NUMBER 137

April 26, 1955

SUBJECT: PA-23 Landing Gear CO₂ Extension System

MODELS AFFECTED: All Model PA-23 Aircraft Incorporating CO₂ Emergency Landing Gear Extension System

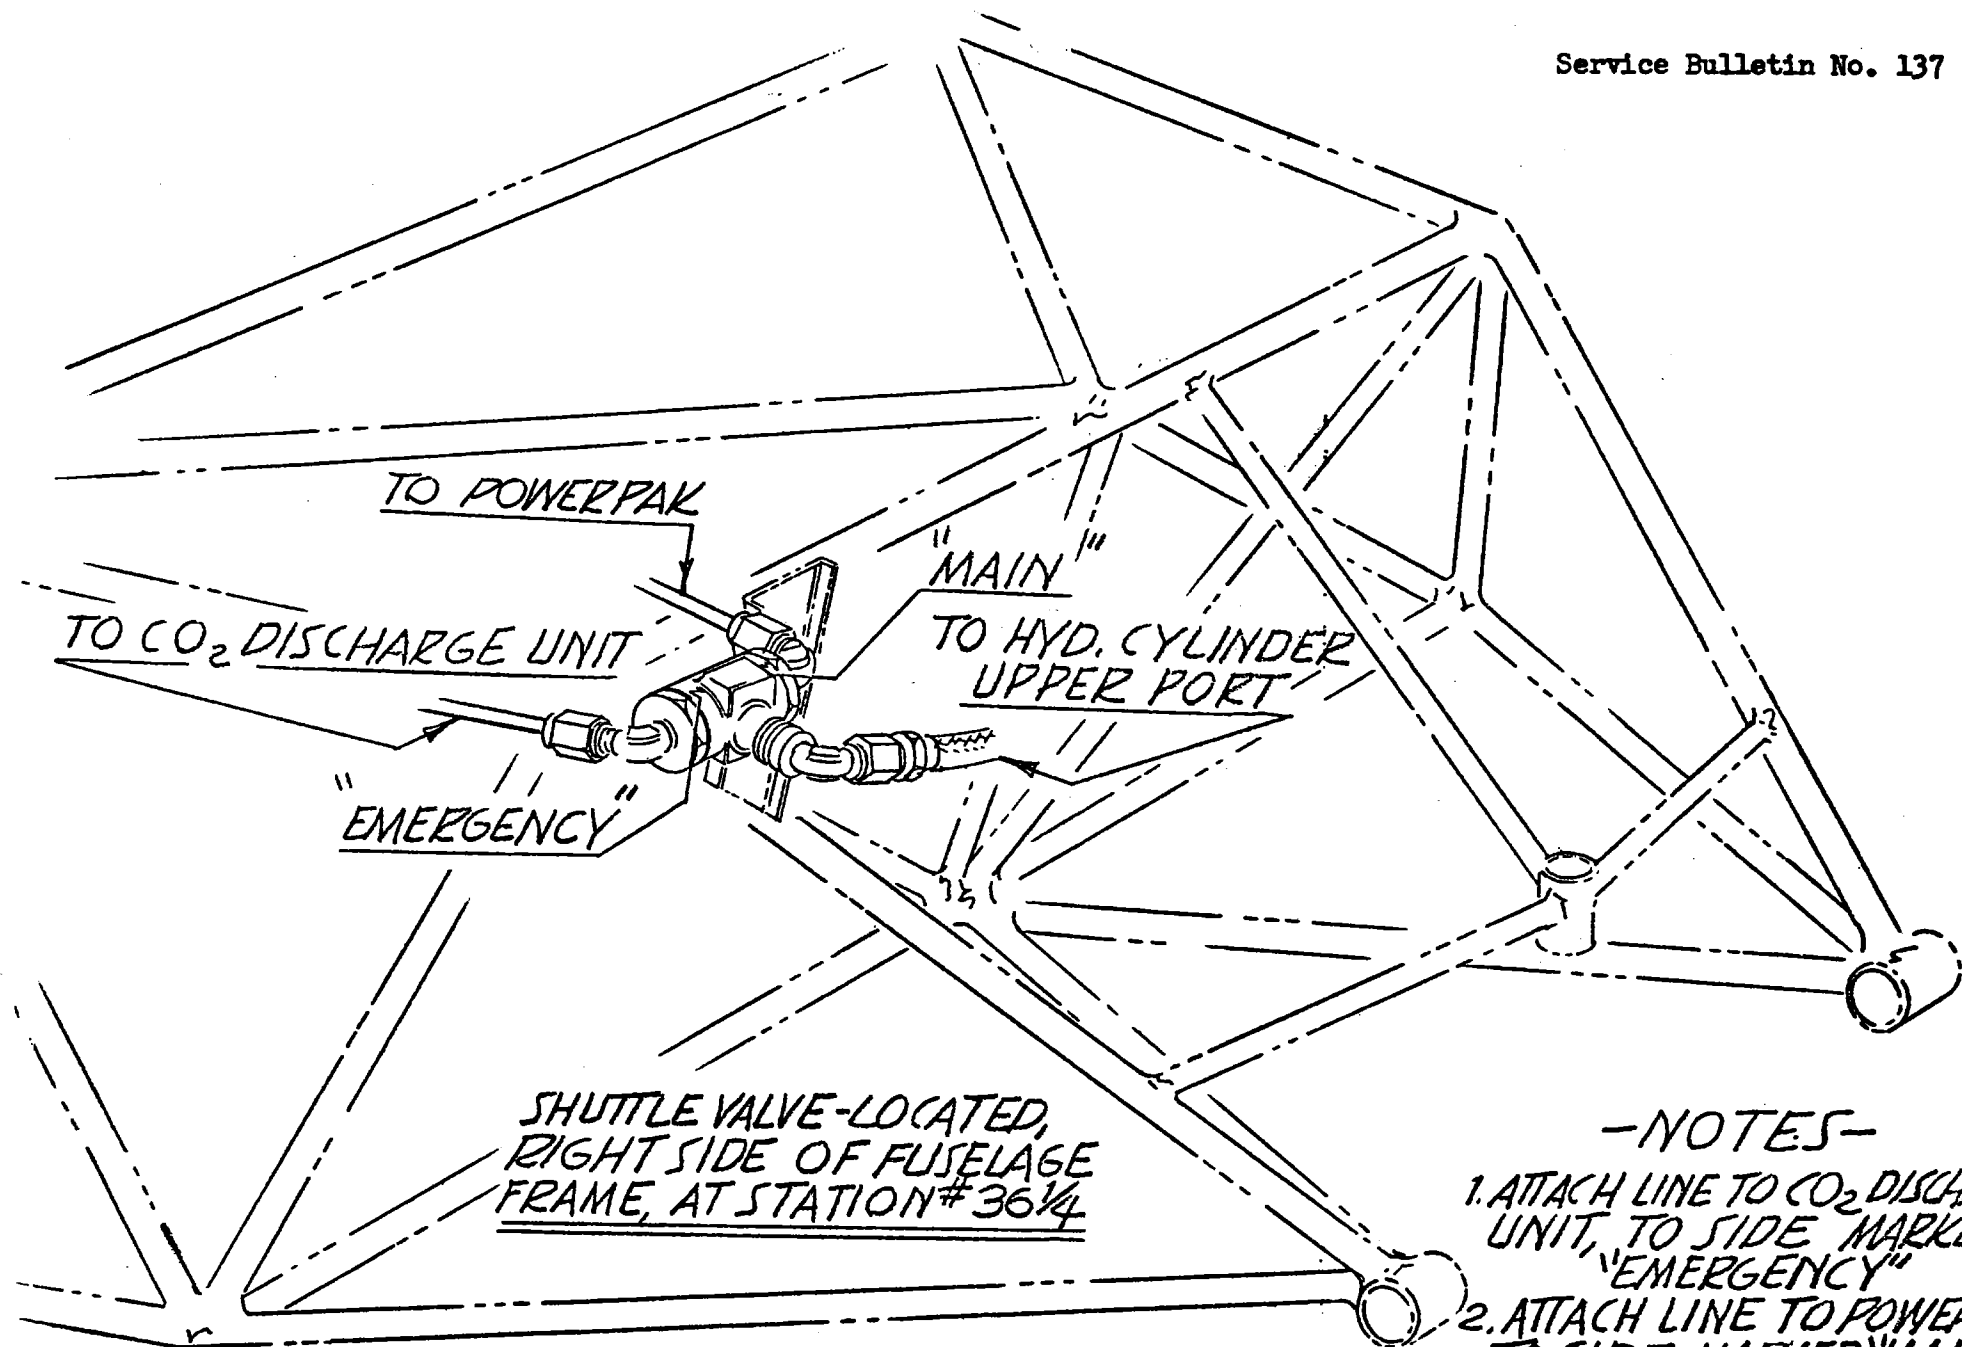
From operational experience in the subject airplanes it has been found that the nose wheel shuttle valve can become unseated, thereby permitting the CO₂ system lines to be filled with hydraulic fluid locking the landing gear in the down position.

The only means of retracting the gear is to bleed the CO₂ system lines. Therefore, in order to eliminate this condition it is necessary to immediately install one spring loaded shuttle valve at the nose wheel actuating cylinder in accordance with the sketch shown on the reverse side of this bulletin.

NOTE: Care should be taken in installing the new nose wheel valve to see that the airplane is put on jacks and that the main hydraulic line is attached to the end of the shuttle valve marked MAIN, and the CO₂ line is attached to the end of the shuttle valve marked EMERGENCY.

1. ATTACH LINE TO CO₂ DISCHARGE UNIT, TO SIDE MARKED "EMERGENCY"
2. ATTACH LINE TO POWERPAK TO SIDE MARKED "MAIN"
